## **AMENDMENTS TO THE DRAWINGS**

This amendment is filed in response to the Office Action mailed January 11, 2005. Claims 1-27 are currently pending. The Examiner rejected claims 1-8, 14, 19-21, and 24-27 under 35 U.S.C. §102(b) and claims 9-13, 15-17, and 22-23 under 35 U.S.C. §103. The Examiner objected to claim 18 as depending from a rejected base claim. The Examiner also objected to the specification for failing to refer to reference numbers in the figures. The Examiners objections and rejections will be addressed in turn.

Figure 1B

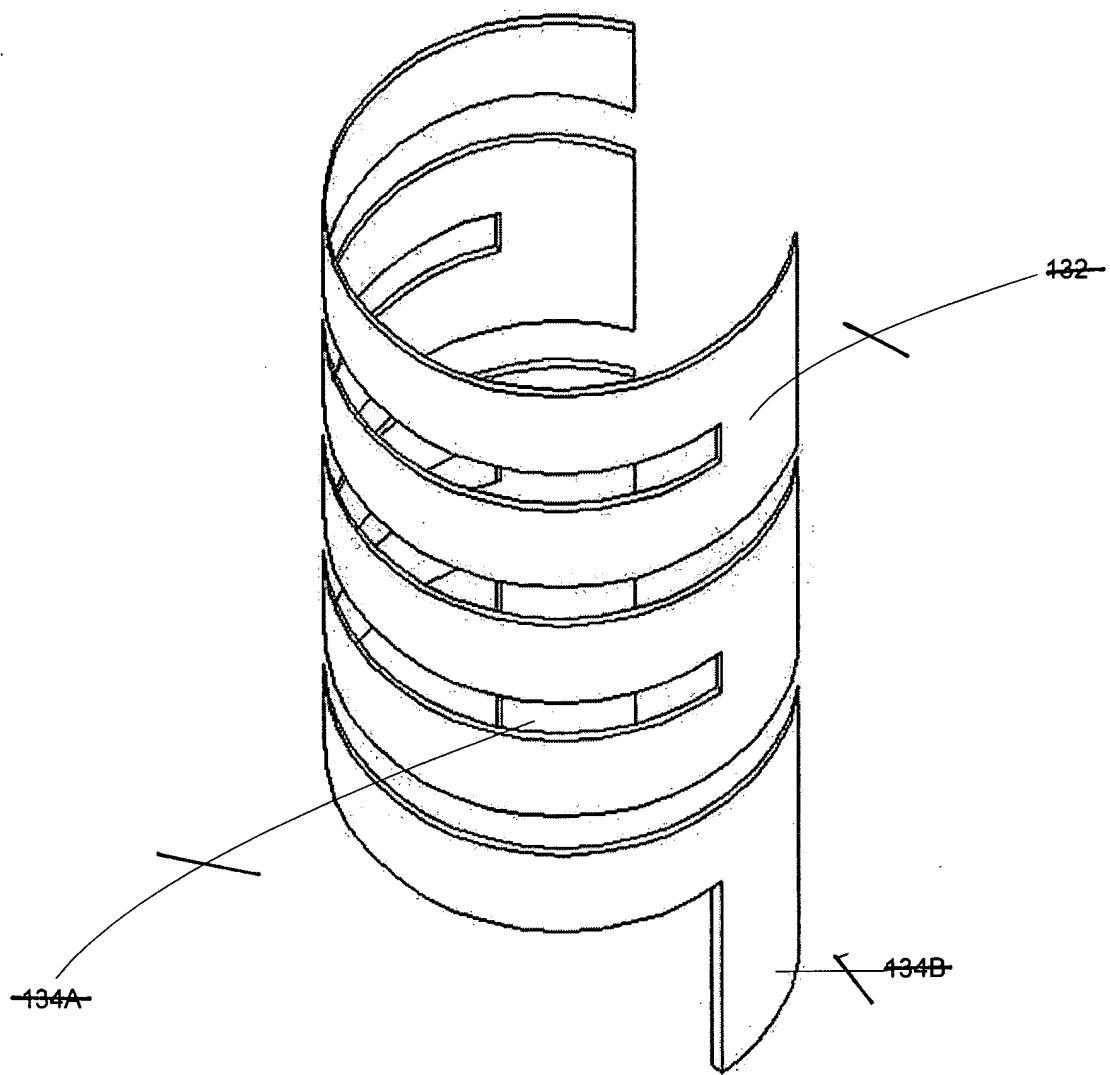
The attached sheet 2 of 12 includes changes to Figure 1B. These changes are the omission of the reference numbers 130, 132, 134A, and 134B and the omission of the lead lines for reference numbers 132, 134A, and 134B.

Figure 6A

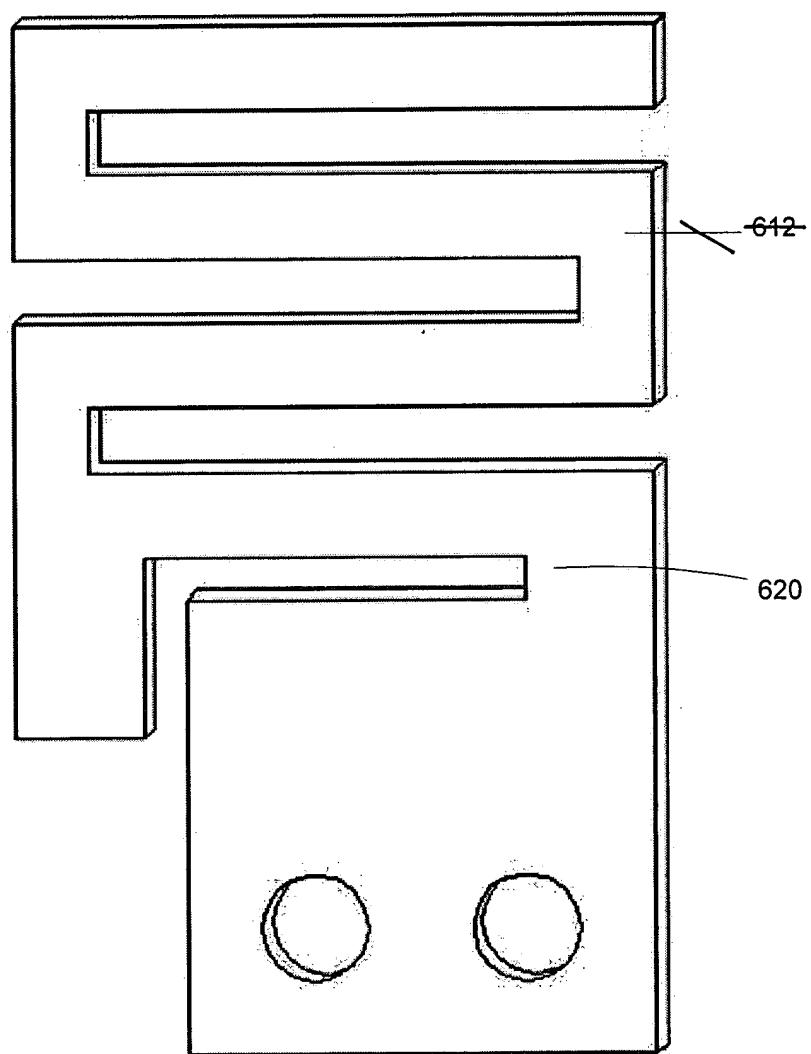
The attached sheet 10 of 12 includes changes to Figure 6A. These changes are the omission of the reference numbers 610 and 612 and the omission of the lead line to reference number 612.

Figure 6B

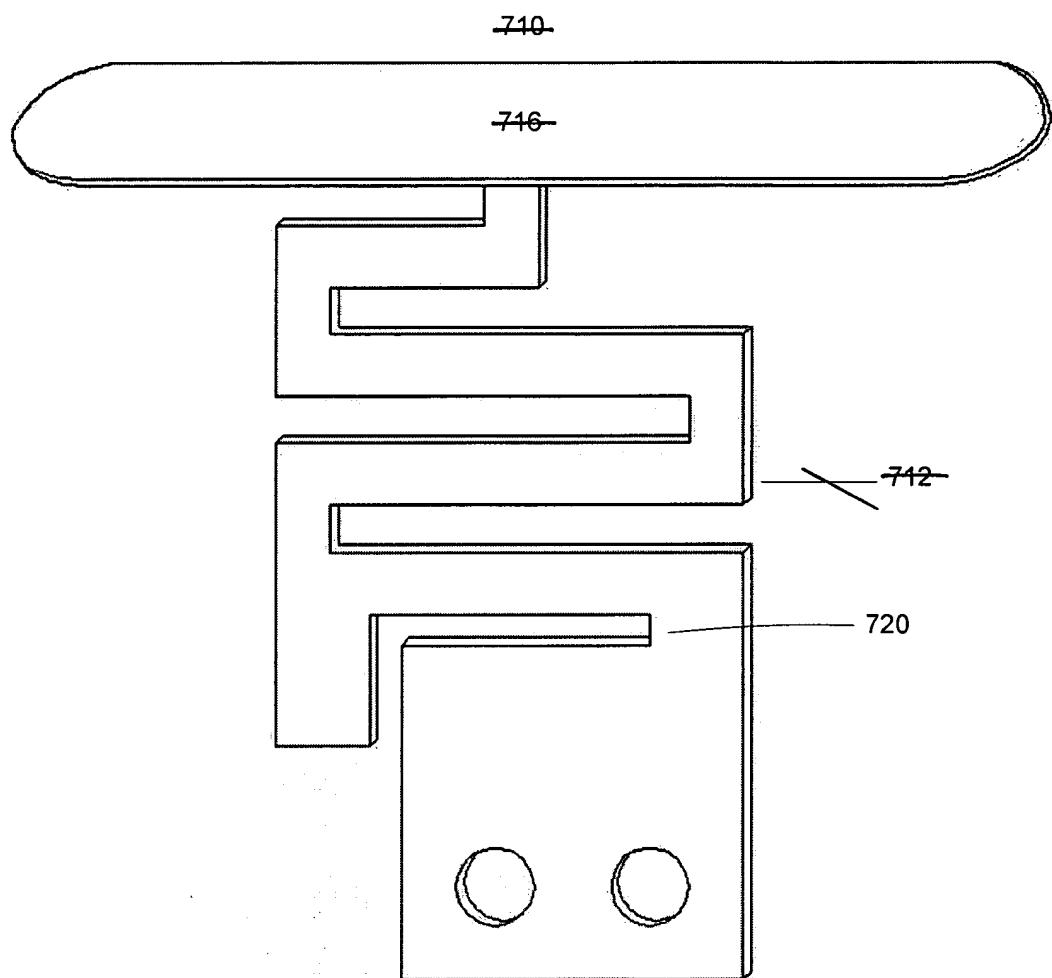
The attached sheet 11 of 12 includes changes to Figure 6B. These changes are the omission of the reference numbers 710, 712, and 716 and the omission of the lead line to reference number 712.

Figure 6C

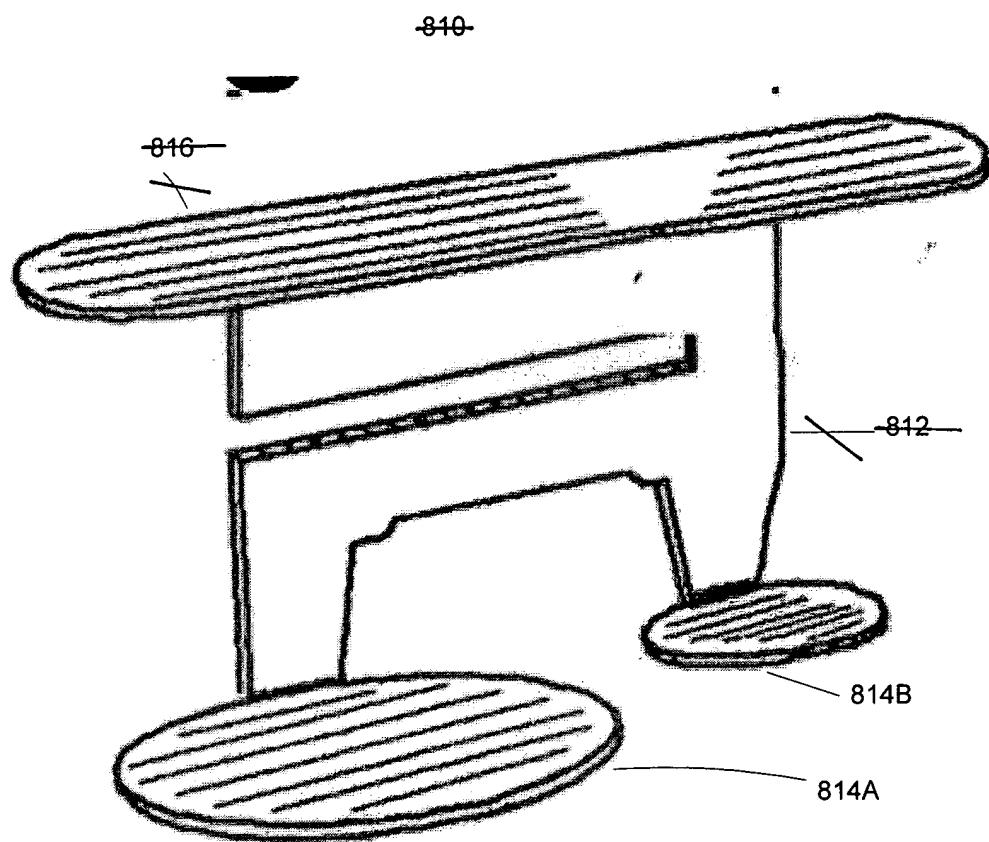
The attached sheet 12 of 12 includes changes to Figure 6C. These changes are the omission of the reference numbers 810, 812, and 816 and the omission of the lead lines to reference numbers 812 and 816.
